Complete Monograph

2024 GROUP A PROPOSED CHANGES TO THE I-CODES

April 7 – 16, 2024
Doubletree by Hilton
Universal Orlando - Orlando, FL

FIGURE 1207.11.7.1 ESS VEHICLE IMPACT PROTECTION

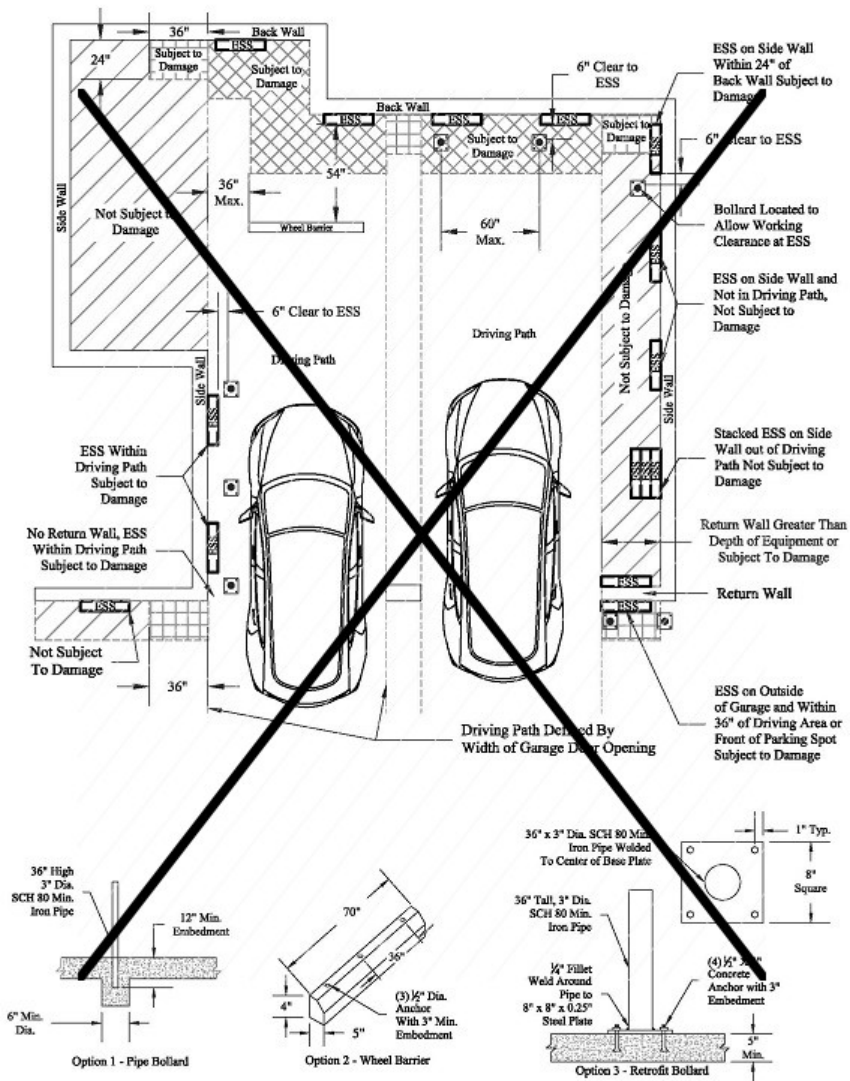
~~Where an ESS is installed in the normal driving path of vehicle travel within a garage, impact protection complying with Section 1207.11.3 shall be provided. The normal driving path is a space between the garage vehicle opening and the interior face of the back wall to a height of 48 inches (1219 mm) above the finished floor. The width of the normal driving path shall be equal to the width of the garage door opening. Impact protection shall also be provided for an ESS installed at either of the following locations (see Figure 1207.11.7.1):~~

FIGURE 3203.9(1) EVALUATION OF CARTONED COMMODITIES CONTAINING GROUP A PLASTICS^{a, b}

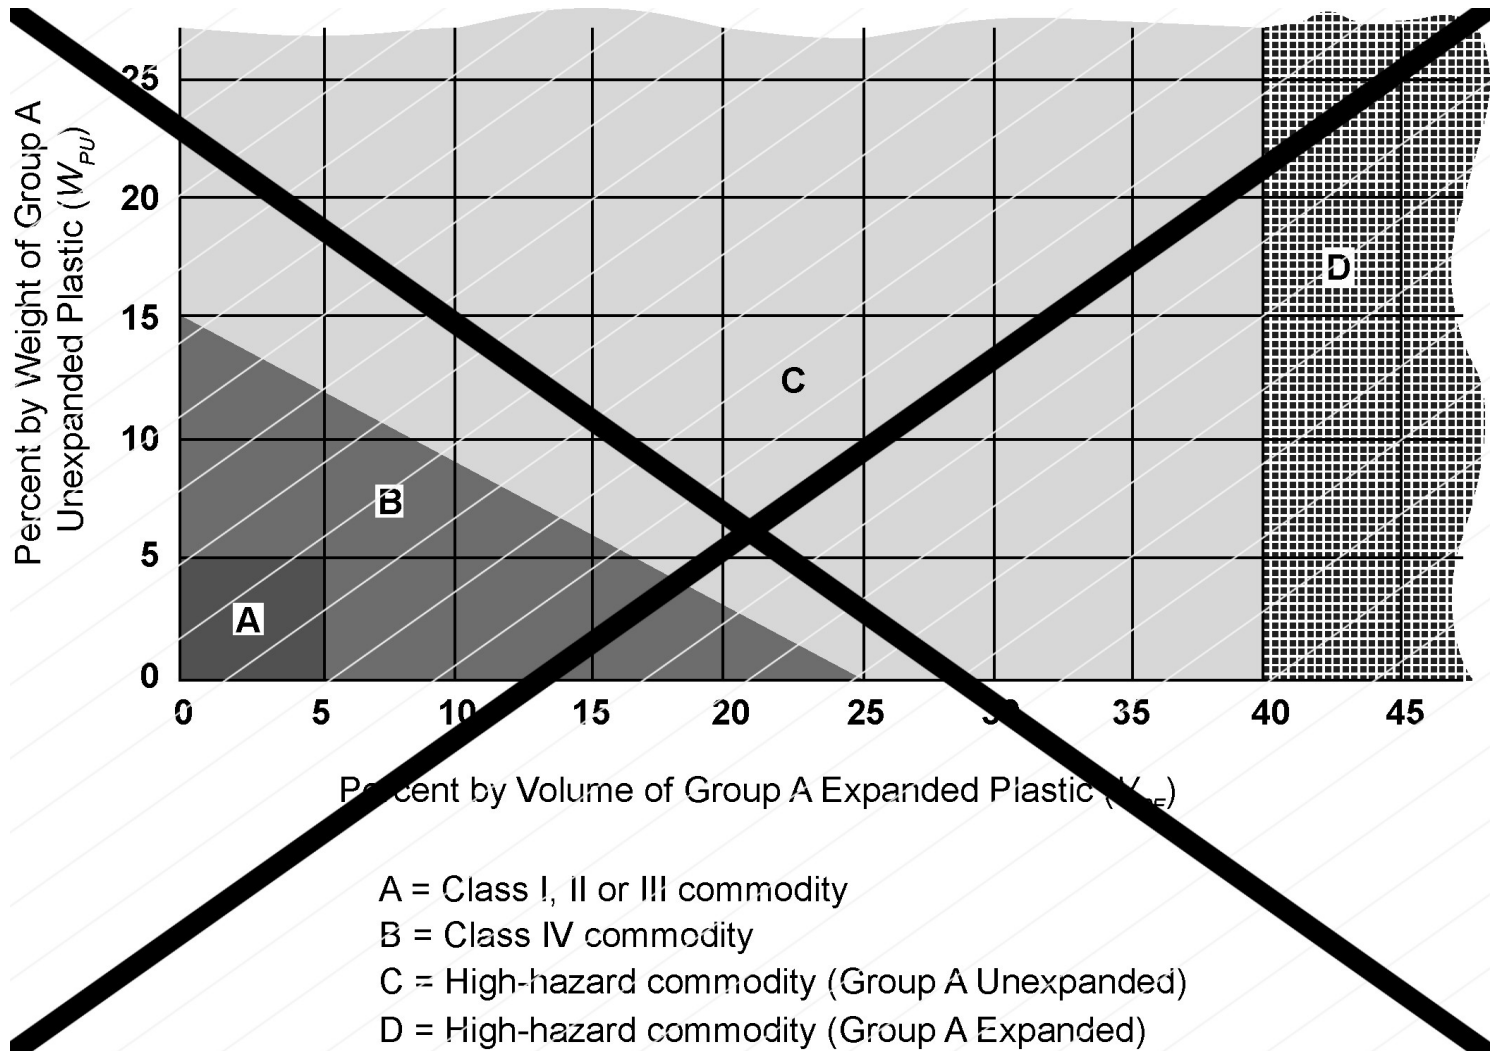
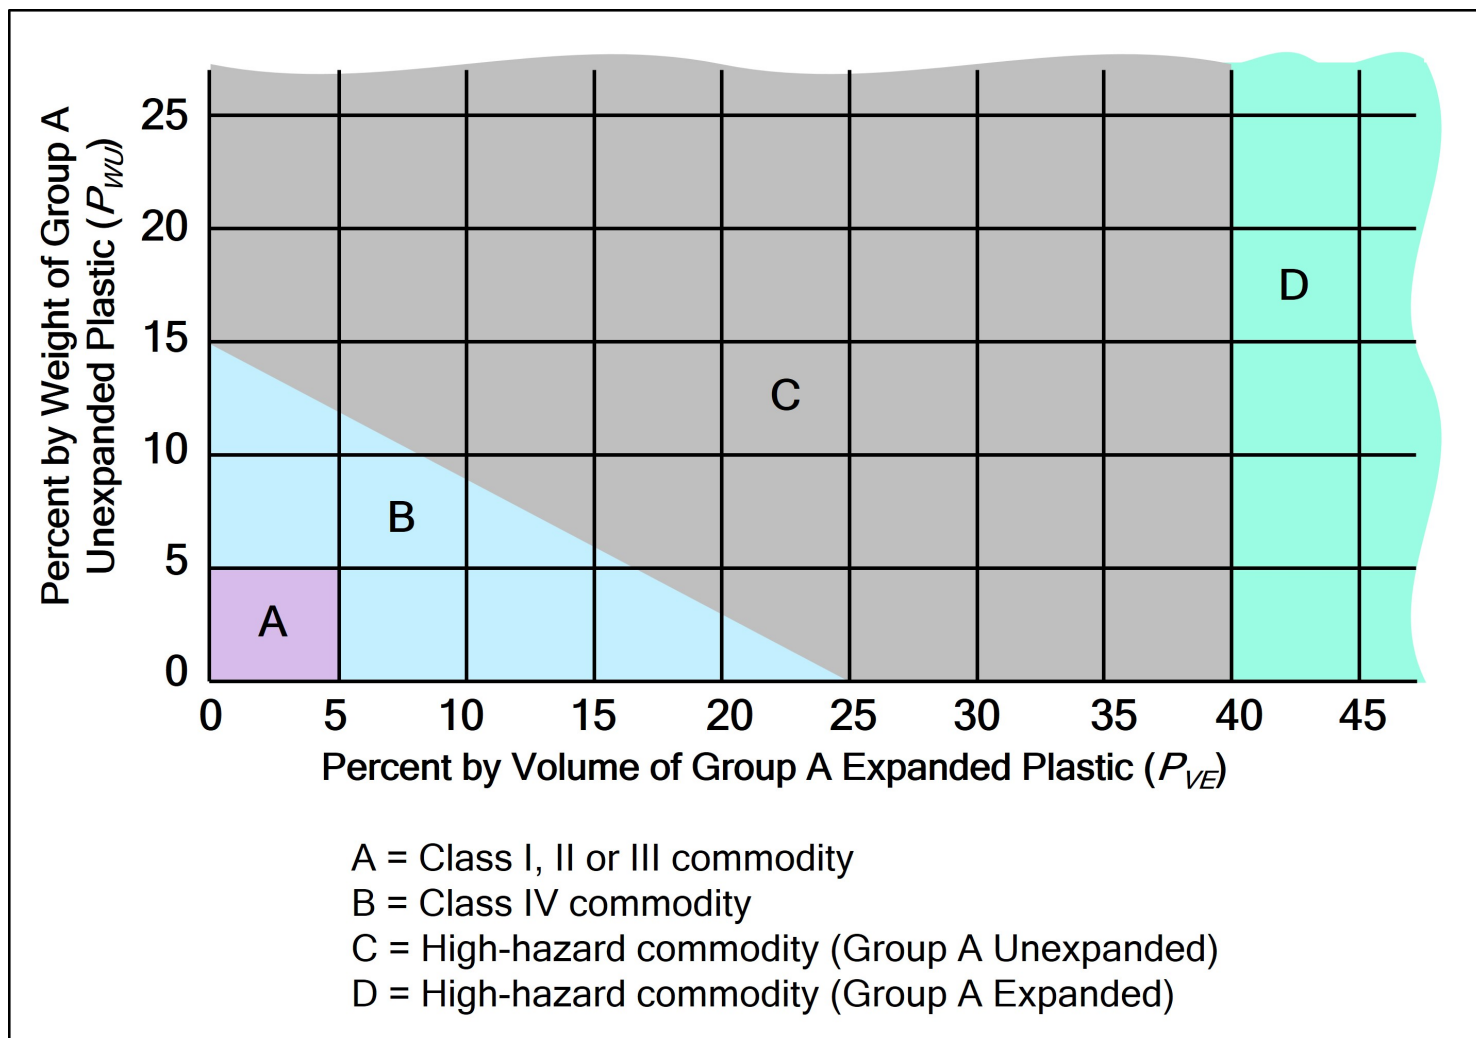
Figures 3203.9(1) and (2) were revised in the 2021 IFC to alter their use. However, some of the code text needing revision to correlate was missed. This proposal correlates the text with the figures.

Figure 3203.9(1) is revised. The only changes are the parenthetical acronyms for Percentage by Weight of Expanded plastic (PWE) and Percentage by Volume of Unexpanded plastic (PVU). This is done to correlate with the terms in Equations 32-1 and 32-2.

Only one figure is required to complete the calculation of the impact of Group A plastic. Figure 3203.9(1) is used for classifying commodities which are cartoned, boxed, or crated. Figure 3203.9(2) is used for classifying commodities which are exposed. To facilitate this difference, a new definition is added for exposed Group A plastics. This definition is consistent with the definition in NFPA 13.

The percentage of Group A plastics determined in accordance with Section 3203.9.2 shall be used in Figures 3203.9(1) and 3203.9(2). ~~Results from Figure 3203.9(1) must be compared to results from Figure 3203.9(2) and the commodity will be classified with the highest commodity classification. Commodities with products in cartons, boxes or crates shall use Figure 3203.9(1). Commodities with exposed Group A plastics shall use Figure 3203.9(1).~~
